SERVICE TIP—POWER TRANSFER UNIT (PTU)— RIGHT HAND INTERMEDIATE SHAFT SEAL LEAKS

TSB 09-25-7

This article supersedes TSB **09-8-10** to update the vehicle model years, vehicle line application and Part List.

Figure 1 - Article 09-25-7

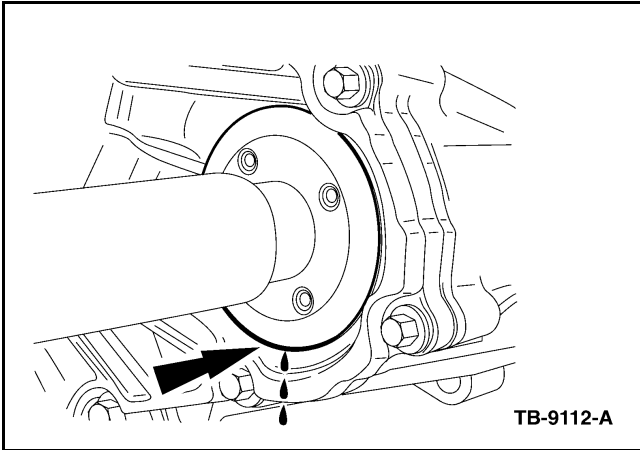
Red automatic transmission fluid (ATF) is not used in the PTU itself. The RH intermediate shaft passes from the transaxle through the input hub of the PTU, where the intermediate shaft seal is located. A red ATF leak indicates fluid from the transaxle is leaking past this intermediate shaft seal contained in the PTU. Use the seal kit, which contains four pieces: the intermediate shaft seal, alignment washer, deflector, and seal protector tool. The intermediate shaft seal, alignment washer, and deflector need to be installed individually and before the seal protector tool is used.

Brown/Black Fluid Indicates a True PTU Seal Leak

Use the seal kit, which contains five pieces: the PTU cover seal, intermediate shaft seal, alignment washer, deflector and seal protector tool. The intermediate shaft seal, alignment washer, cover seal, and deflector need to be installed individually and before the seal protector tool is used. Use seal kit, which contains the PTU cover seal, intermediate shaft seal, alignment washer, and deflector. All four parts need to be installed individually.

REFER TO (FIGURES 1 AND 2) THAT IDENTIFIES THE LOCATION OF THE PTU LEAKS.

Figure 3 - Article 09-25-7

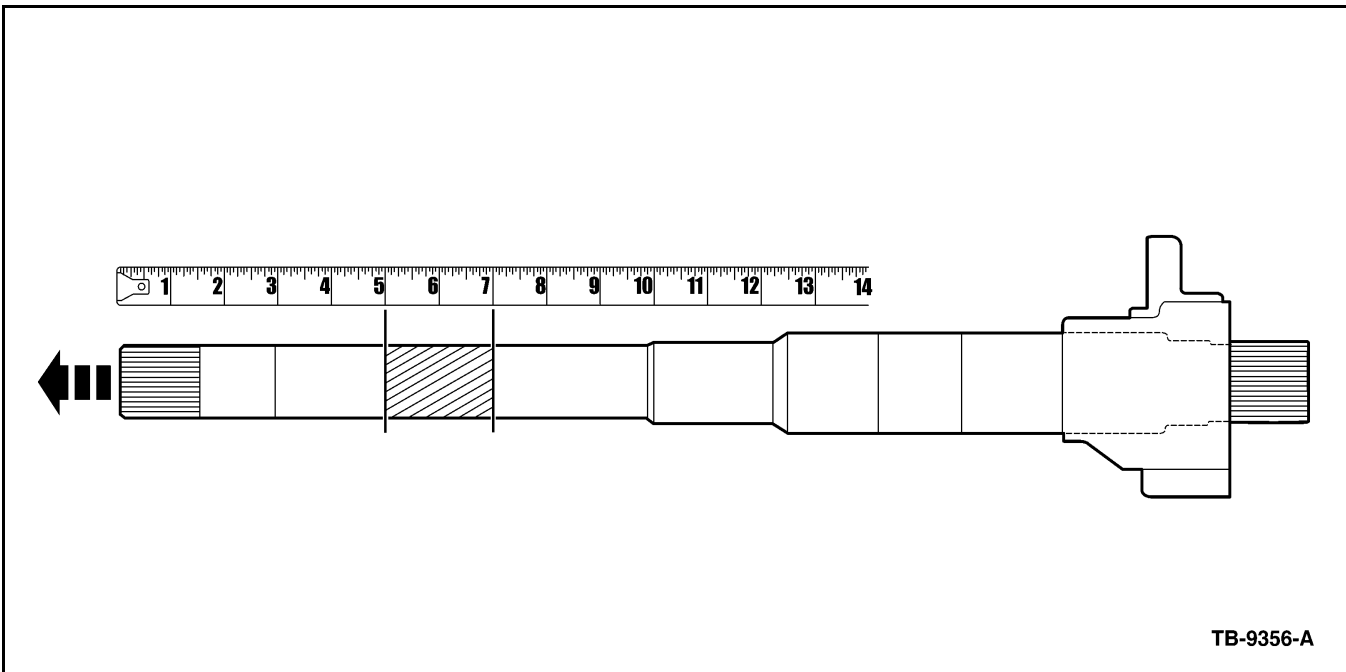
- Intermediate Shaft Seal - Retains red ATF used in the transaxle.
- Alignment Washer - Supports and centers the intermediate shaft in the seal.
- Deflector - Keeps dust and dirt away from the intermediate shaft and PTU input shaft seals.
- Seal Protector Tool - which is a one time use, keeps the shaft splines from contacting intermediate shaft seal during installation to prevent the seal from being damaged. It is very important to remove the seal protector off the intermediate shaft during the installation at the proper distance to prevent seal damage. (Figure 3)

Figure 4 - Article 09-25-7

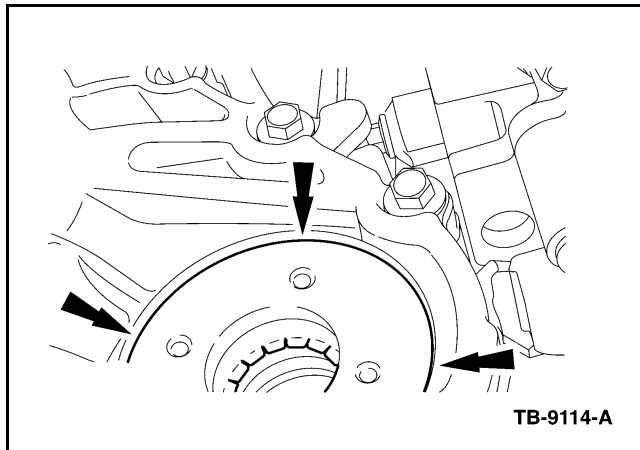
It is necessary to use the updated version of the online WSM, Section 308-07B to perform the actual repair. The service procedure has been updated with new and improved service tools specified. Failing to follow the WSM to perform this repair will result in repeat PTU leaks. Never remove the deflector by use of a pry bar or chisel this will result in damage to the input shaft PTU hub and/or PTU housing. It is very important to properly heat the new deflector to the desired temperature specifications called out in the WSM, prior to installation. Never attempt to heat the deflector on the PTU assembly to seat it, seal damage will result. When the new deflector is properly seated it will be recessed 1/8" - 3/16" (3-5 mm) into the PTU pocket. (Figure 4)

MAKE SURE LINKSHAFT SEAL INSTALLER (205-883) IS CLEAN OF DEBRIS AND THERE ARE NO BURRS THAT COULD DAMAGED THE SEAL PRIOR TO INSTALLATION.
